Coastal Access Modification Report MR1

Proposed changes to the submitted King Charles III England Coast Path proposals for Isle of Wight 3: Culver Down to Binnel Bay

Location affected: Luccombe

August 2023

MR1 - Overview map

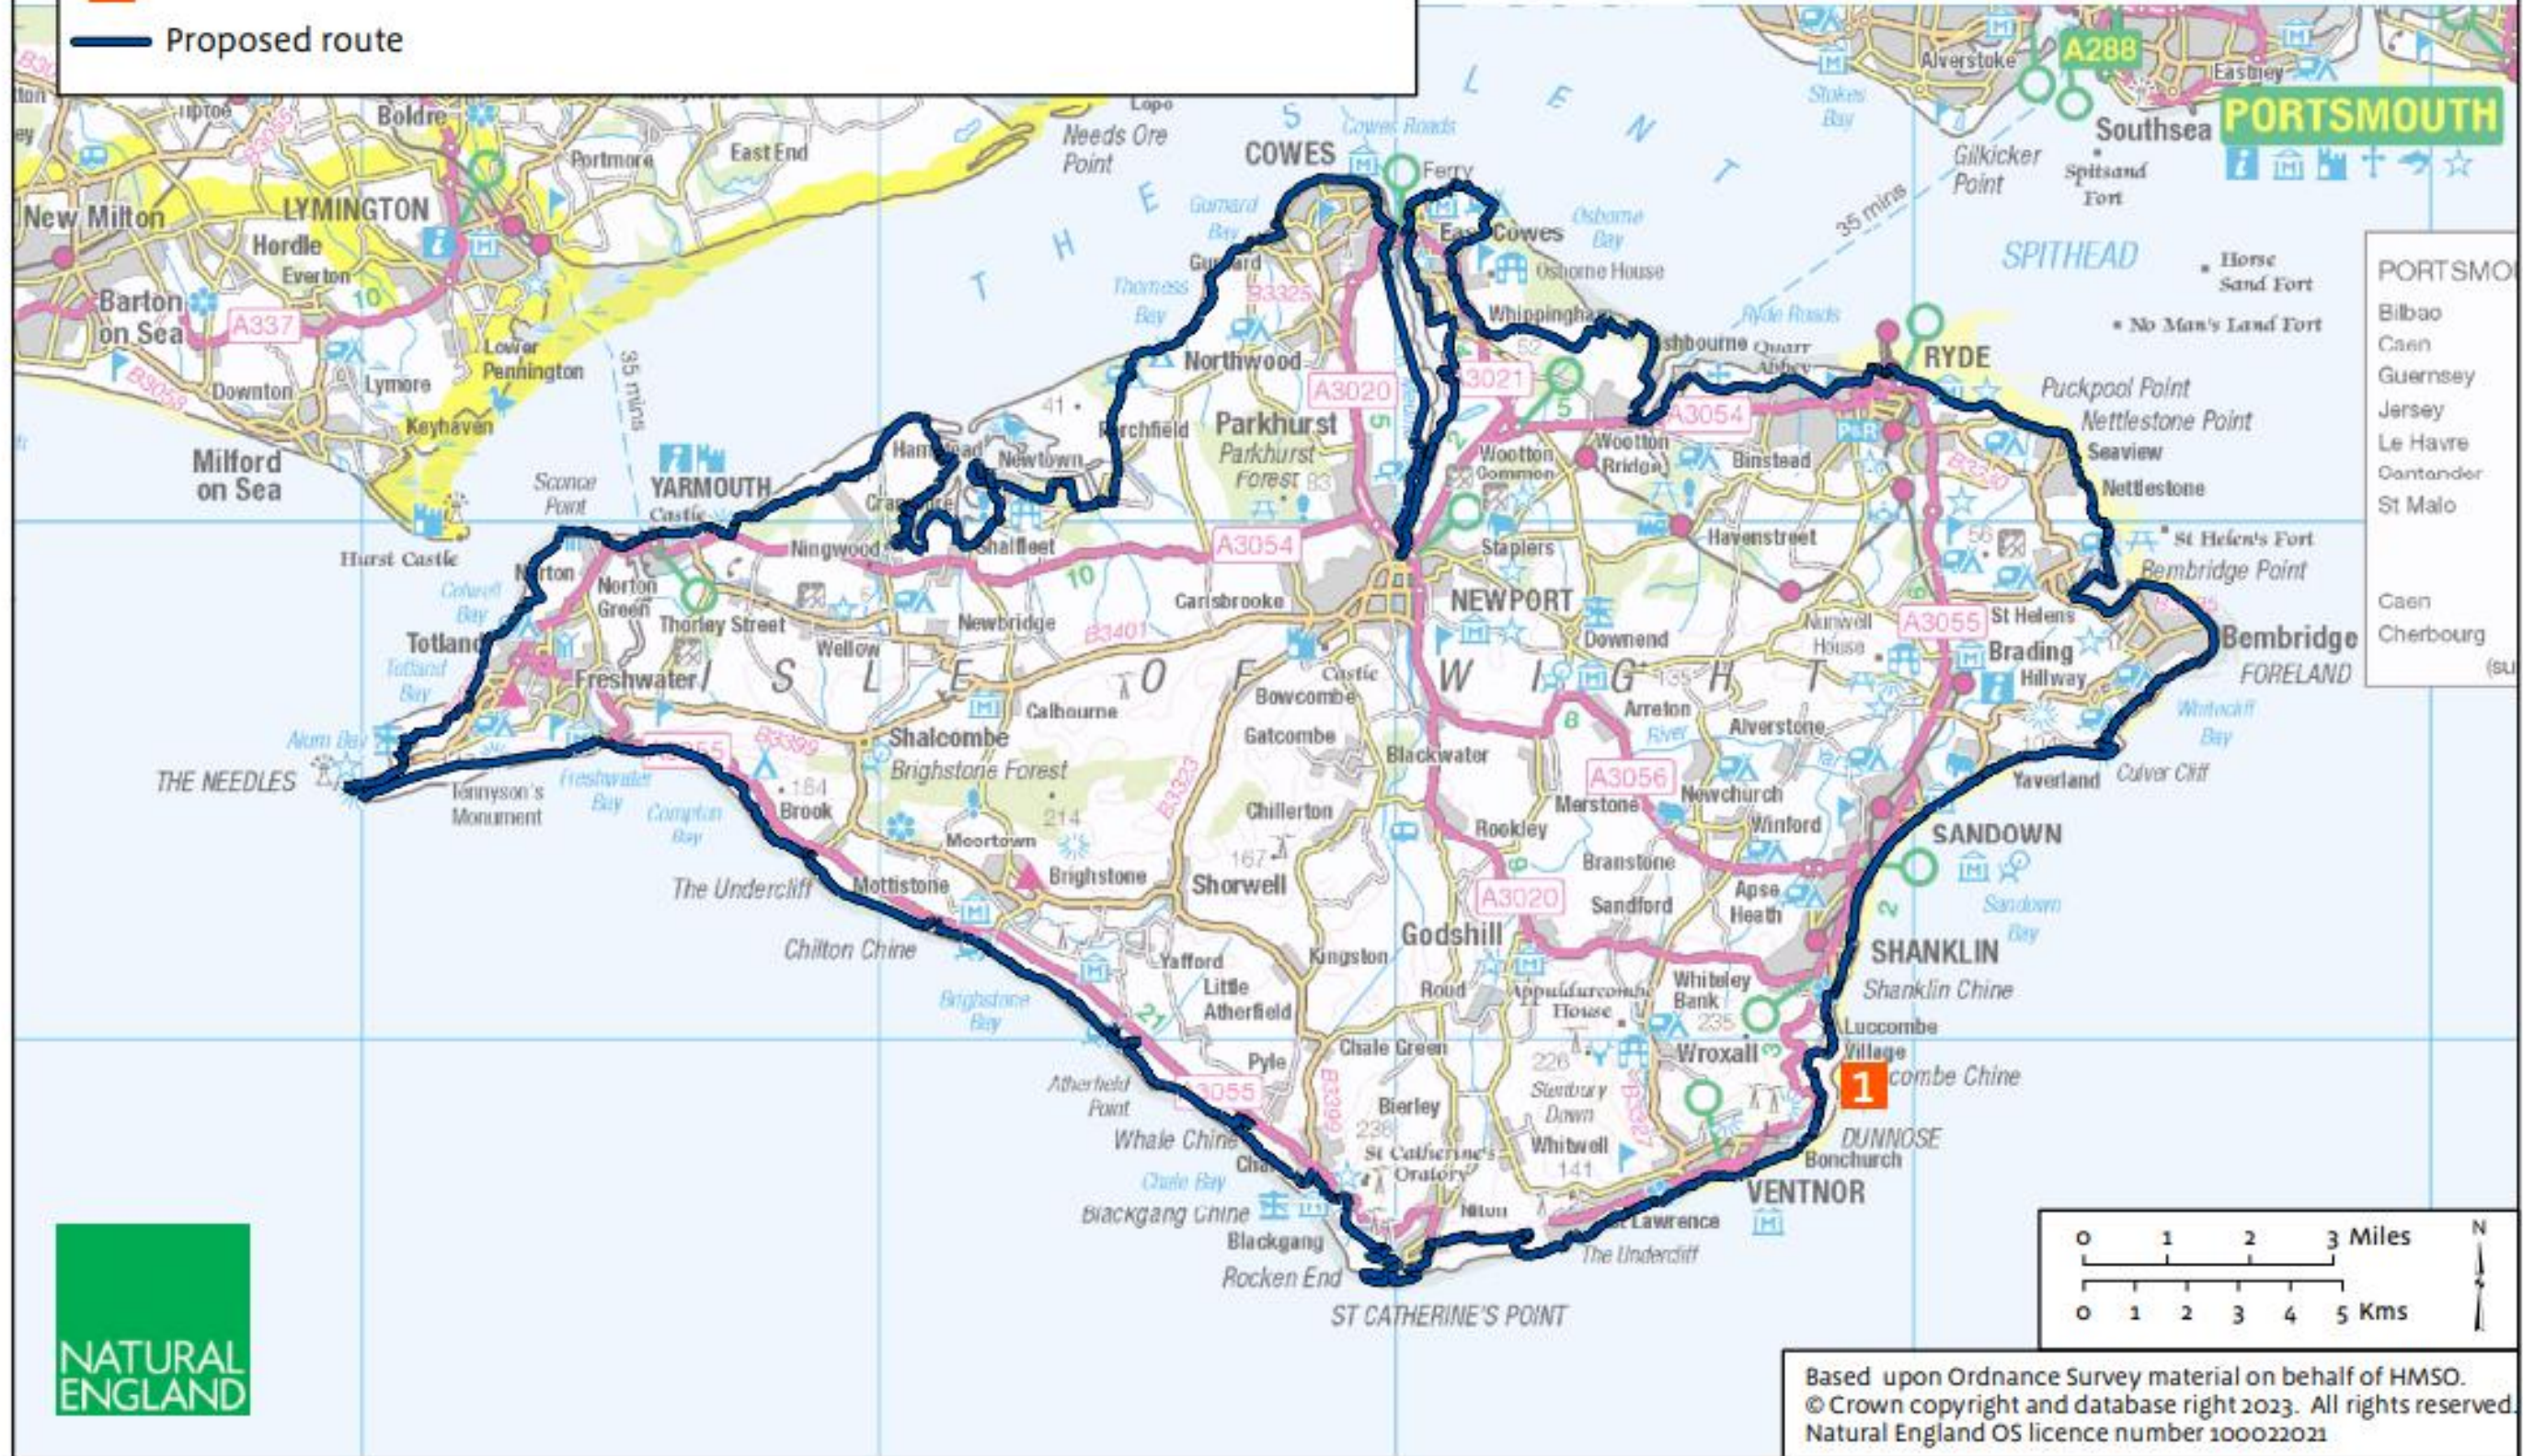
1.4 The change needs to be proposed through a Modification Report (MR), so that it can be considered alongside the rest of Natural England’s original proposals. The proposed change is at the location shown on the Ordnance Survey base map below headed MR1 - Overview Map - Location of modification proposals on Isle of Wight coast:

Map MR1 - Modification 1 - Luccombe

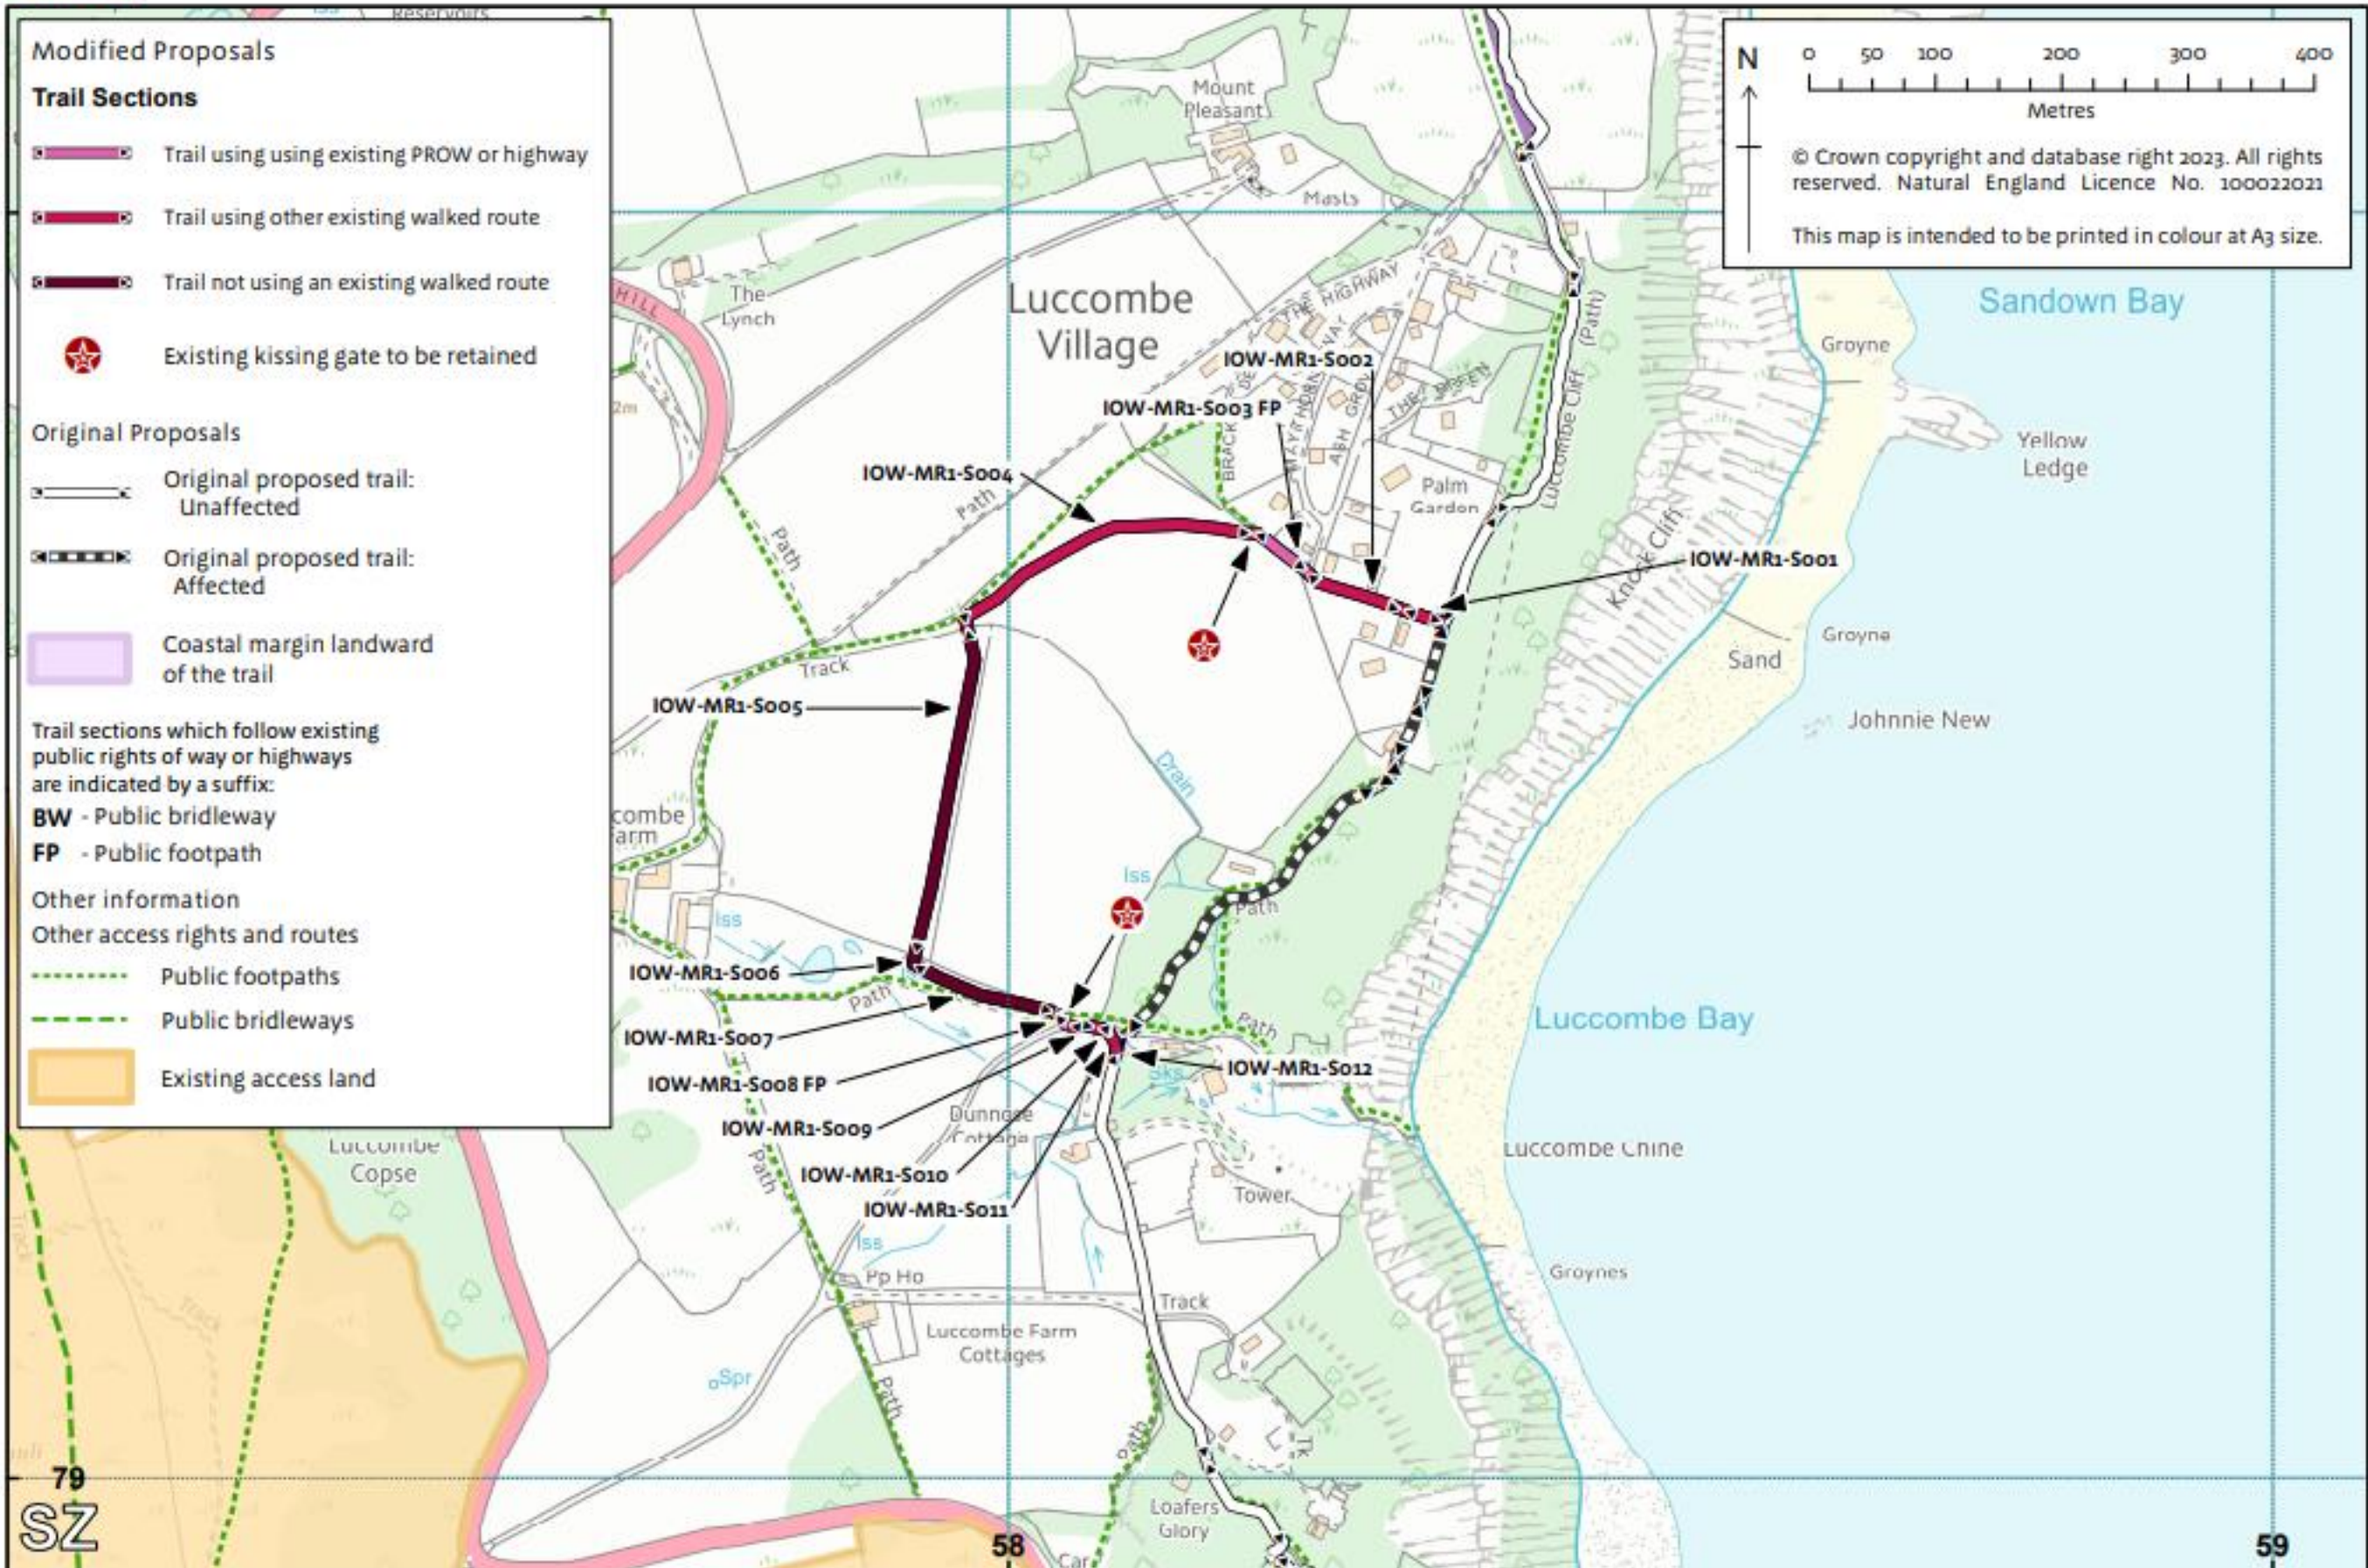
A.1.1 Our original alignment of the King Charles III England Coast Path (KCIIECP) in this area, as proposed in Natural England's [original report](#), followed the existing public right of way (PROW) and Isle of Wight Coast Path along the top of the cliff at Luccombe Chine.

A.1.2 Following a period of heavy rainfall and dramatic land movement, the route had to be closed. On inspection the route was considered too unstable and works to secure the route for public use would not be sustainable. The Isle of Wight Council have closed the footpath on the grounds of health and safety and reopening possibilities are unlikely due to the extent of the damage and unstable conditions.

A.2.1 Our proposal (see Map MR1 - Modification 1 - Luccombe) is, from north to south, to re-route the path inland from that shown as IOW-3-S044 to IOW-3-S048 in our original report. The length of the realigned trail will be 884m, compared to the original route proposed of 452m.

- Goes around the back of the cliff top woodland slope, through a field which has sea views
- Follows the public footpath along sections IOW-MR1-S003 and IOW-MR1-S008
- Follows 'other existing walked routes' along sections IOW-MR1-S001, IOW-MR1-S002, IOW-MR1-S004 and IOW-MR1-S009 to IOW-MR1-S012
- Follows a newly established trail along sections IOW-MR1-S005 to IOW-MR1-S007 across National Trust land
- Re-joins the original trail at the start of section IOW-3-S049
- Is the only viable option as the cliff slope is steep and too unstable to support a trail, and there are people's homes and gardens seaward that would be impossible to avoid

A.2.3 The modified proposal is aligned along existing public footpaths, other existing walked routes or newly created walked routes.

A.2.5 The proposed trail consists of a path with a mixture of a concrete and grass surface. There are slight gradients to the route that may be challenging for those with reduced mobility. We had considered replacing the two existing kissing gates with pedestrian gates leading into and out of the National Trust field, however, this could present problems in the future for control of grazing livestock. In addition, there are no suitable egress and ingress points for parking for wheelchair users in this area and the nature of the terrain on the sections leading south are steep, narrow and there are steps present.

A.2.12 Our estimate of the capital costs for these works is £5,110. This is a decrease of around £15,580 compared to the original route set out in our report to the Secretary of State on 18th March 2020. This is mainly because there will no longer be a need for the construction of two sets of steps on IOW-3-S047 and a reduction in length of aggregate surfacing.
